ADDENDUM NO. 1

ZION HILL ROAD IMPROVEMENTS Salem, New Hampshire January 18, 2018

Zion Hill Road Improvements - Addendum No. 1

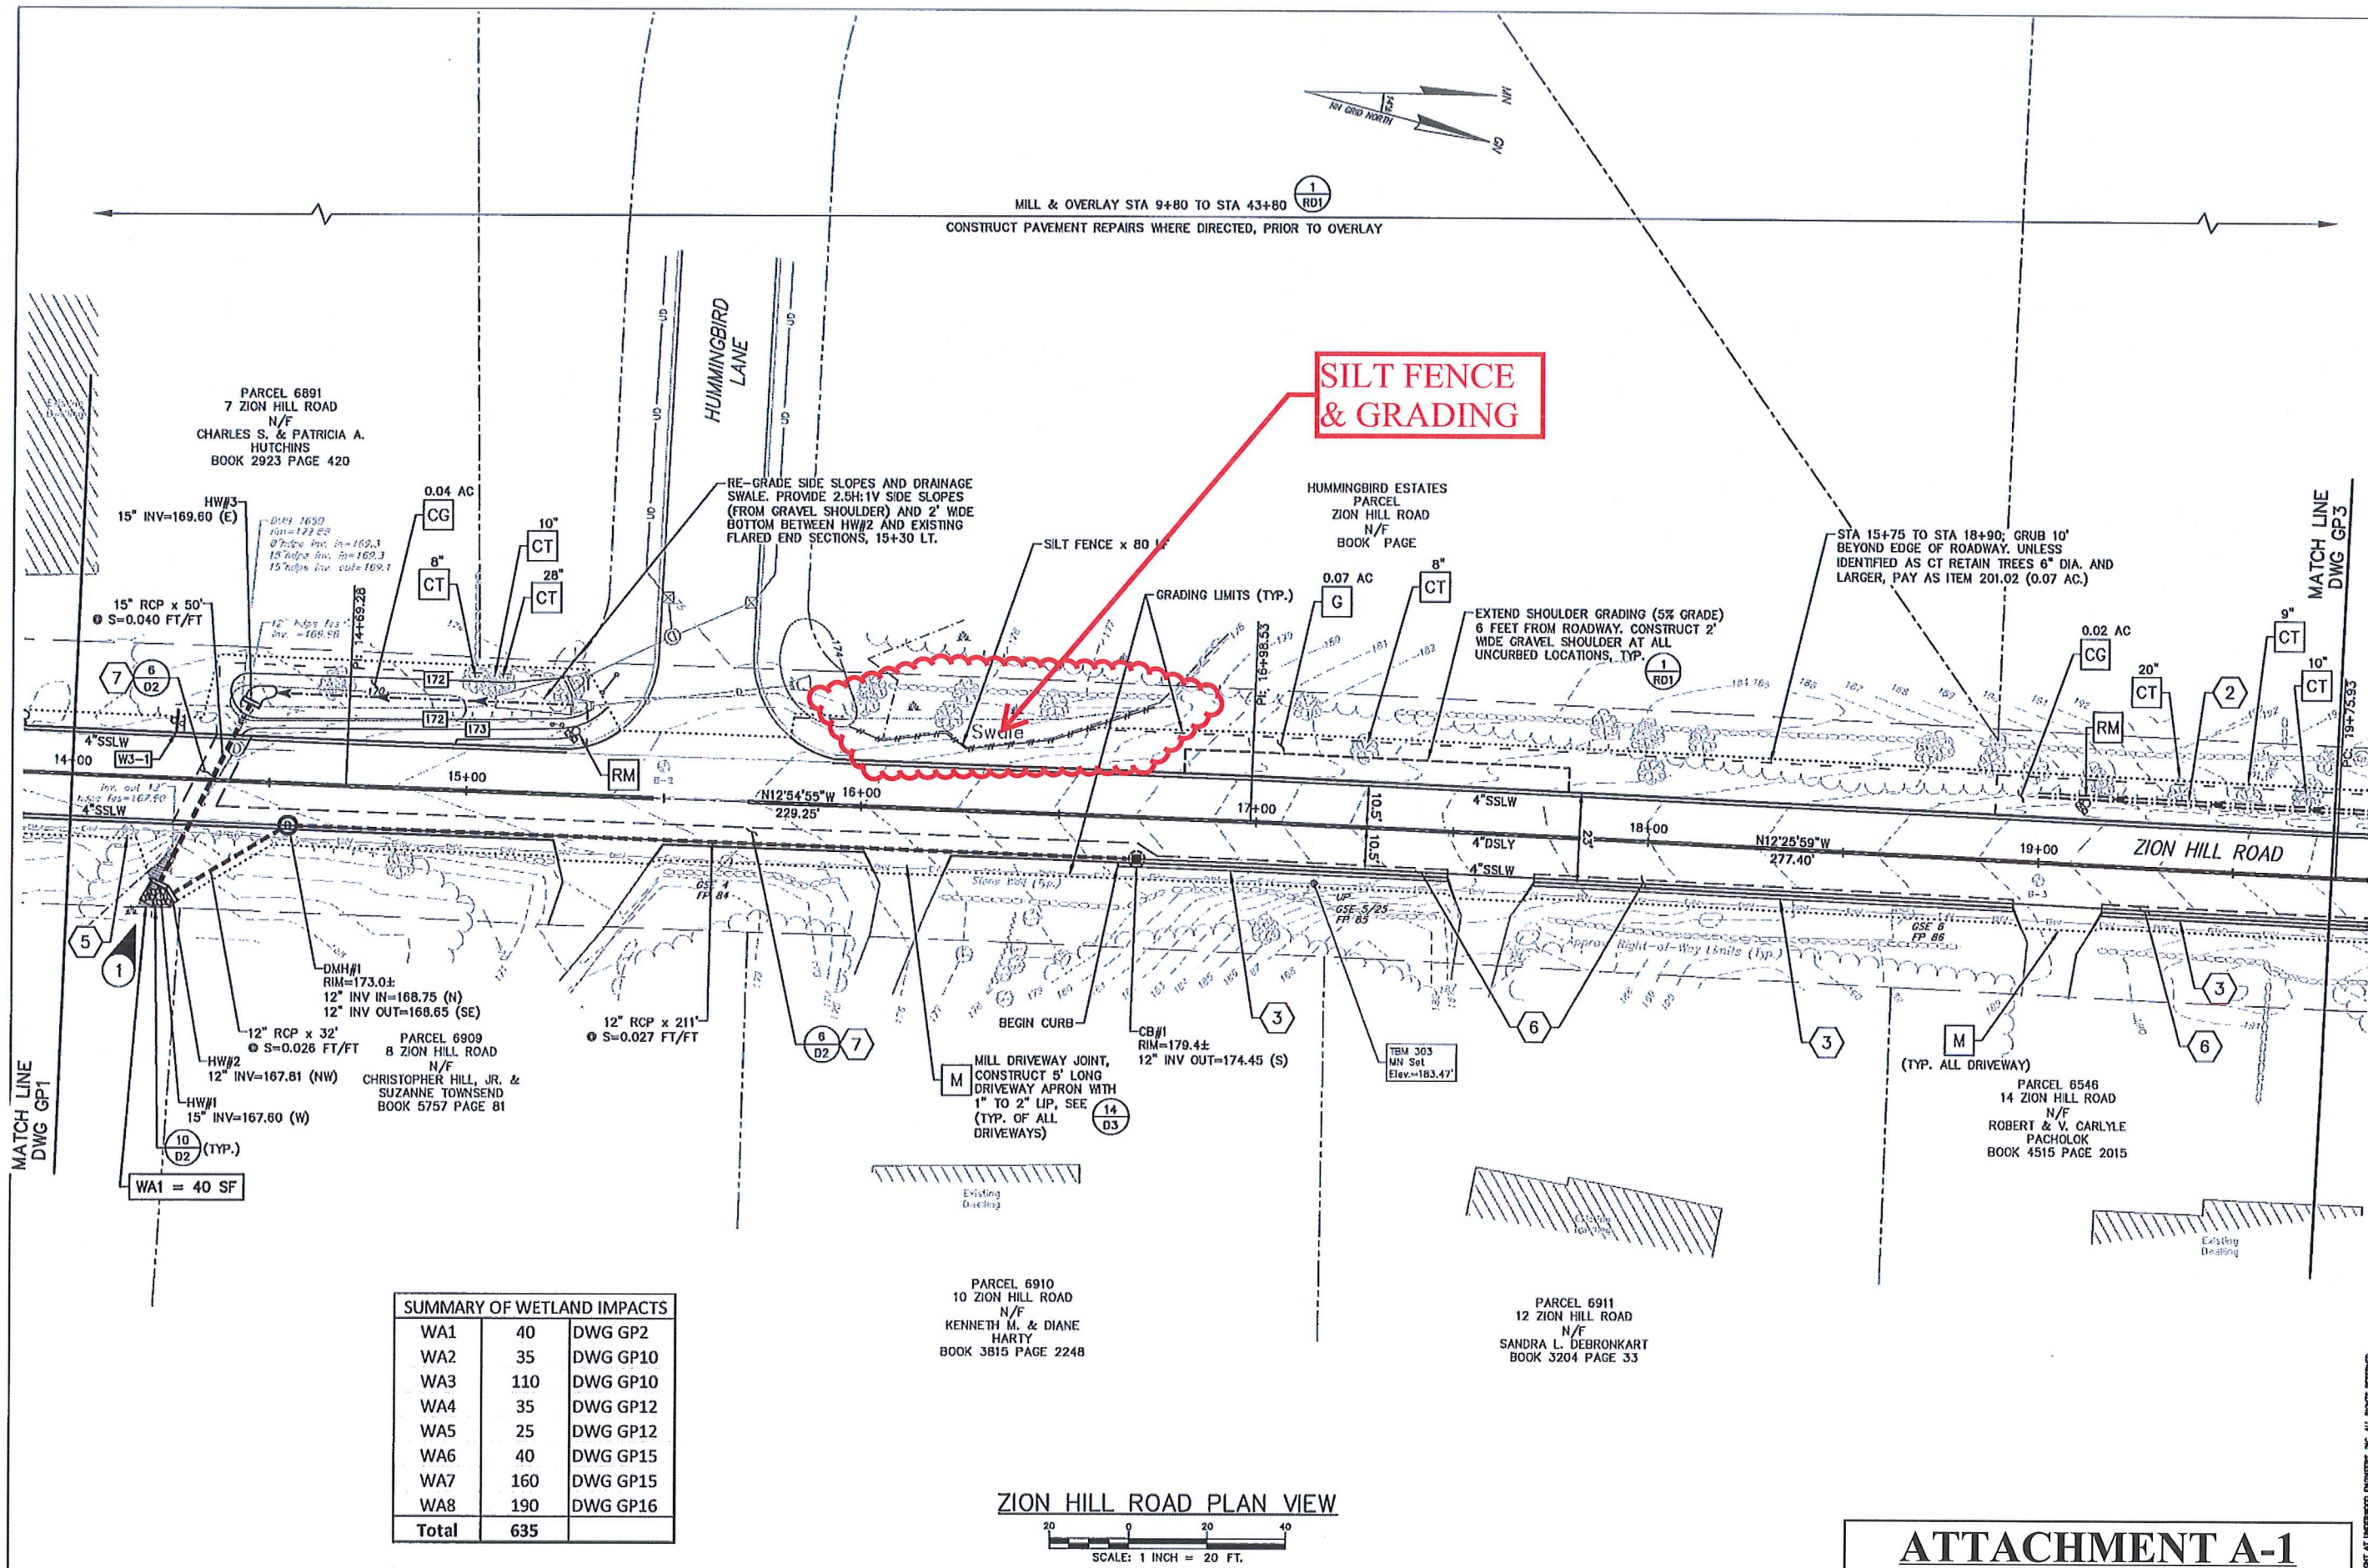
Q: Do the quantities include excavation/gravel quantities for installation of new bituminous curbing adjacent to existing pavement sections in the mill and overlay section.

R: Quantities for curbing installation (common excavation and gravels) are summarized in the Pavement Repair quantity schedule on DWG G3. This sheet has been updated and is being re-issued as part of Addendum #1

DWG NO GP2

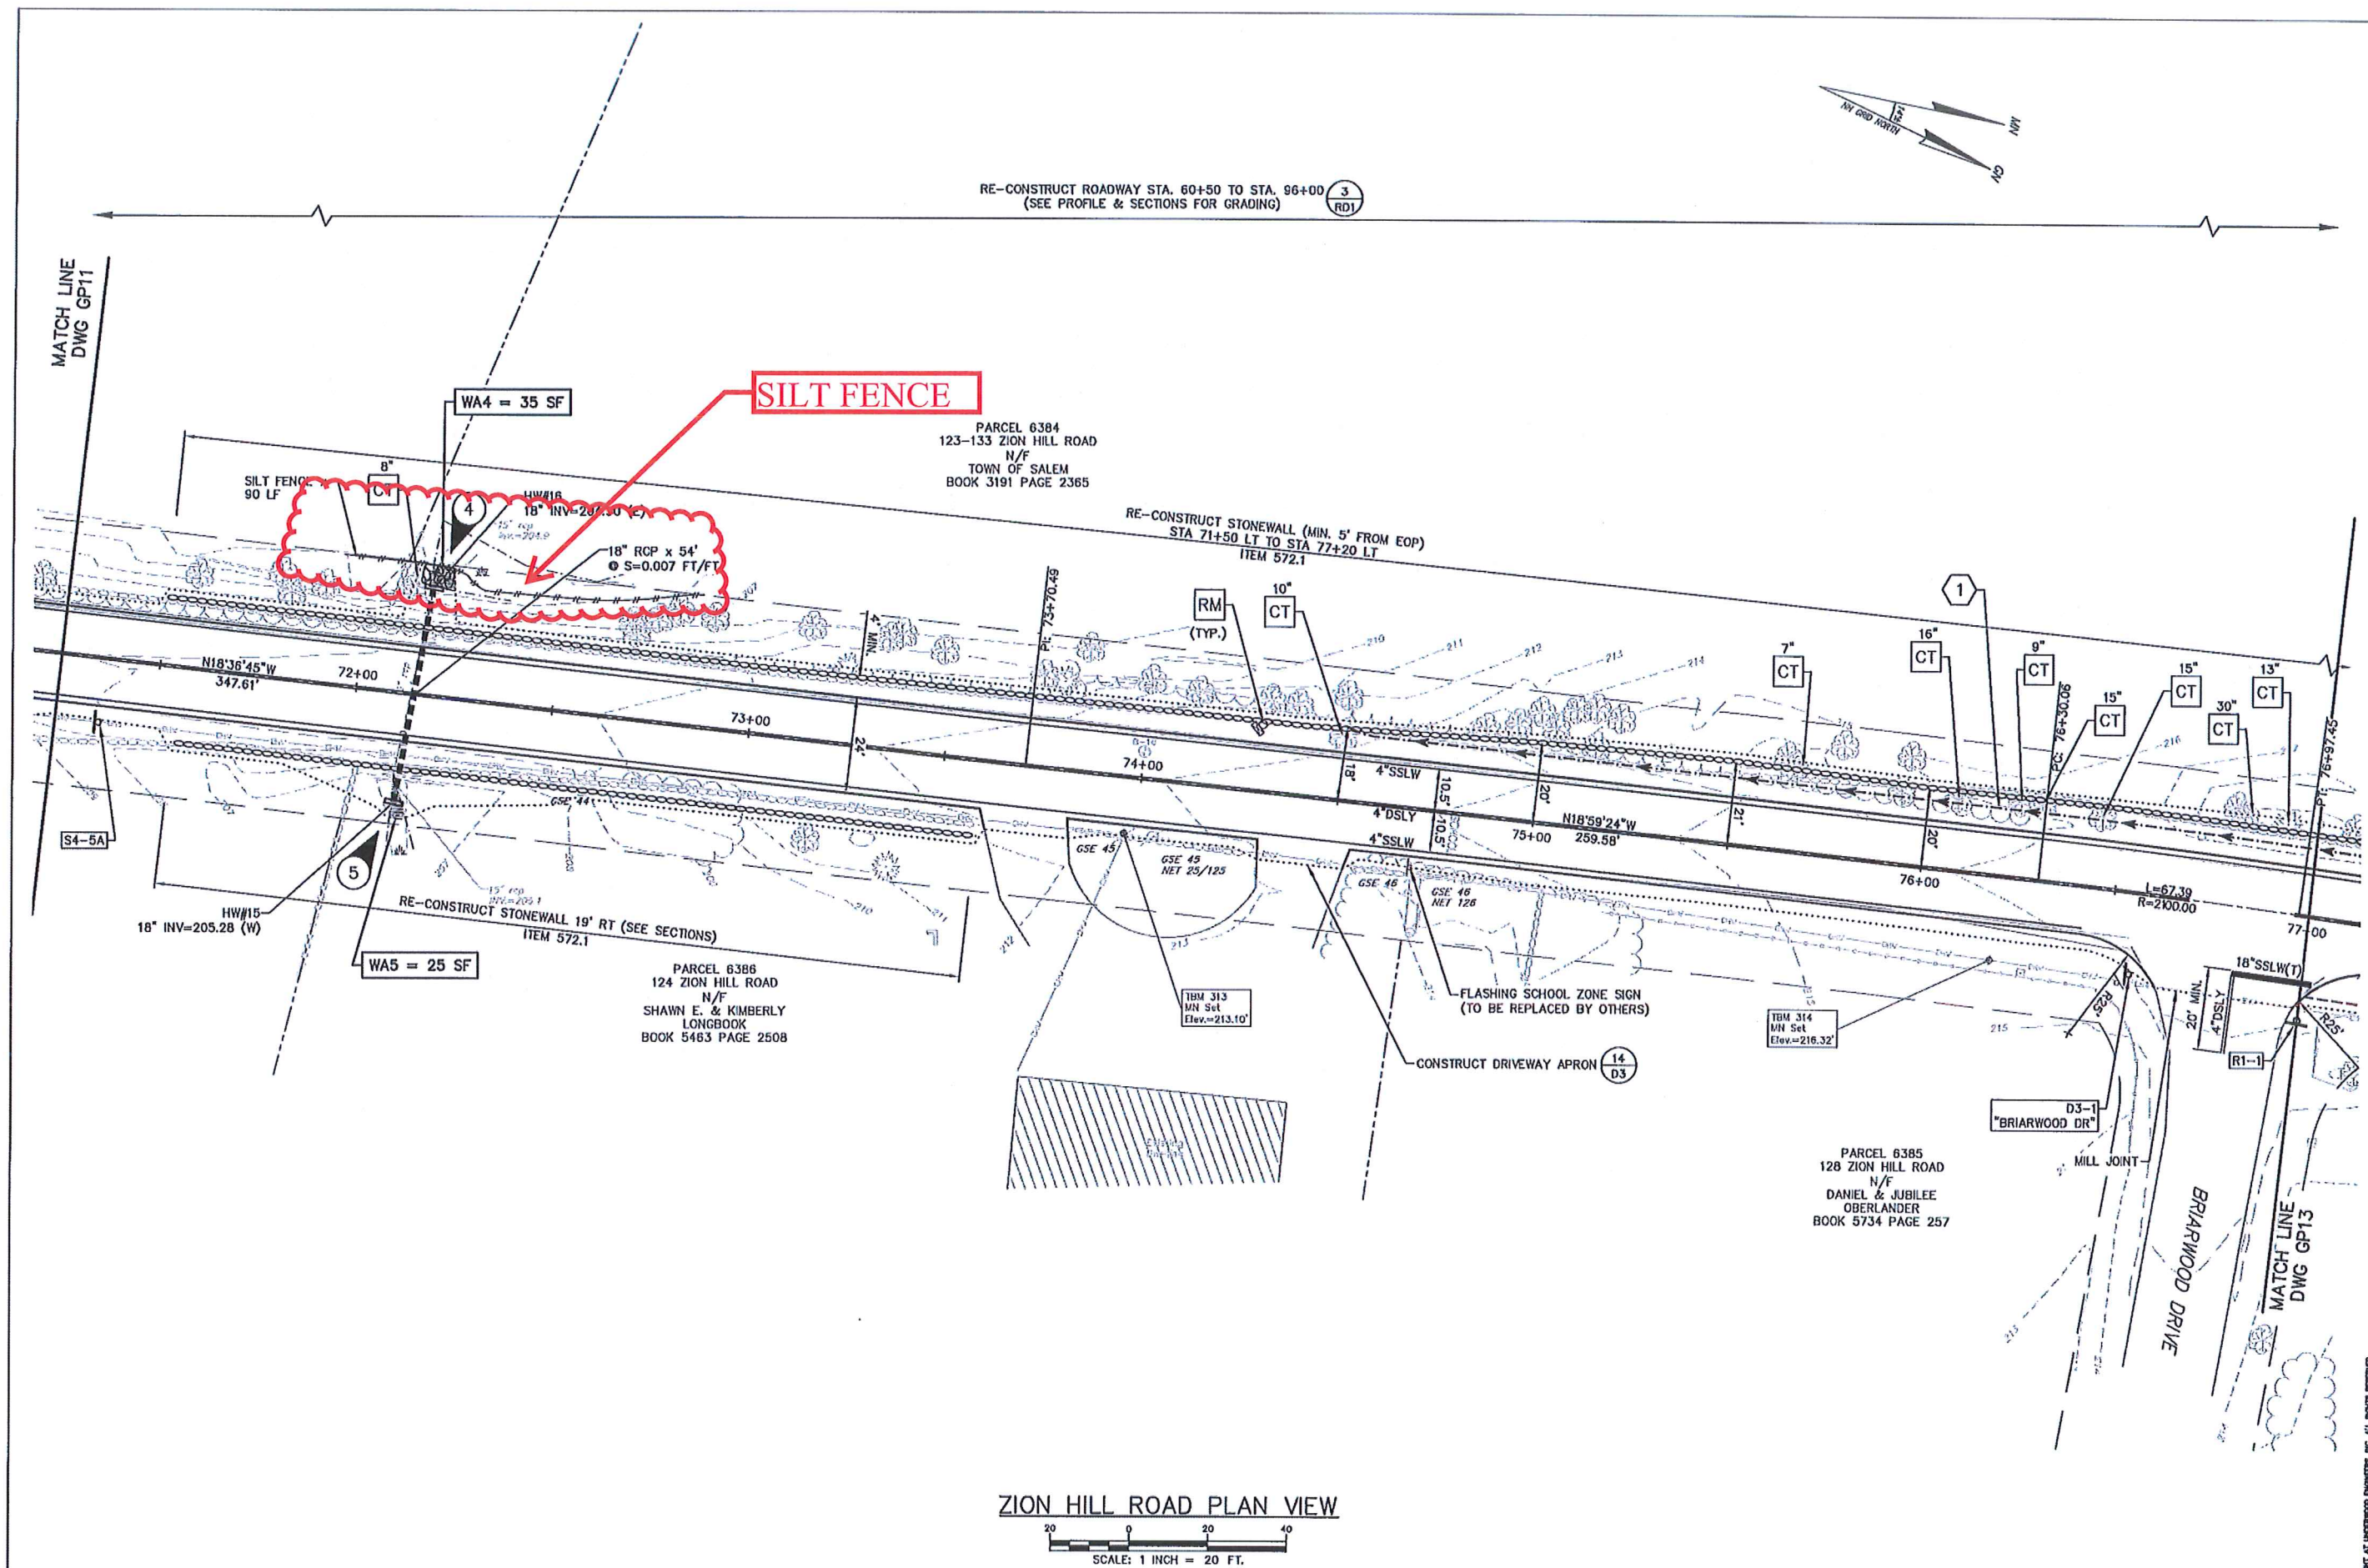
Drawings submitted with the wetlands application show modifications to proposed grading and proposed silt fence locations for work adjacent to jurisdictional wetlands. Impacted sheets are included with these meeting notes as Attachment “A-1” for contractors consideration in preparation of their bids. Silt fence revisions do not affect bid quantity provided for Item 645.531.

FIGURE
A-2

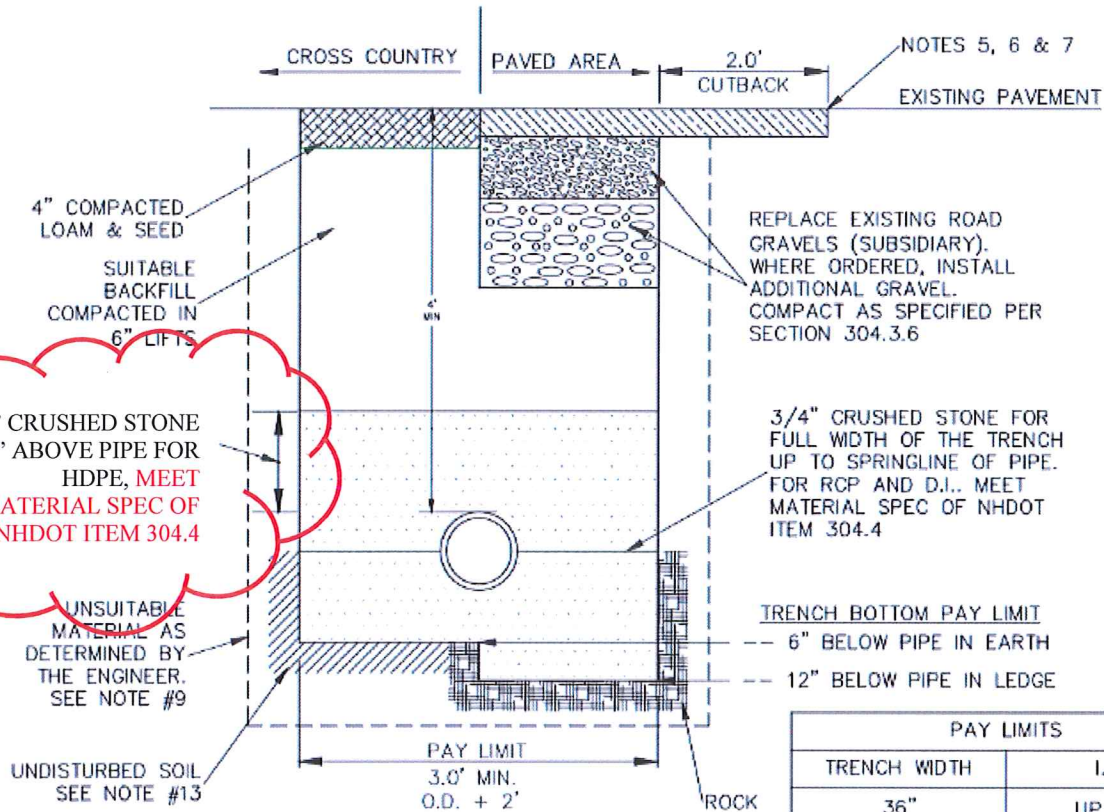
Q: The typical drain trench detail does not call for sand placed over the pipe and note # 4 references Salem Subdivision standards which I believe calls out sand over pipe. Please clarification

R: Drainage pipe shall be installed with 12” stone blanket above the pipe for HDPE pipe. Stone blanket shall meet material specification for NHDOT Item 304.4 and shall be incidental to the respective pipe items (Attachment “A-2” of these notes)
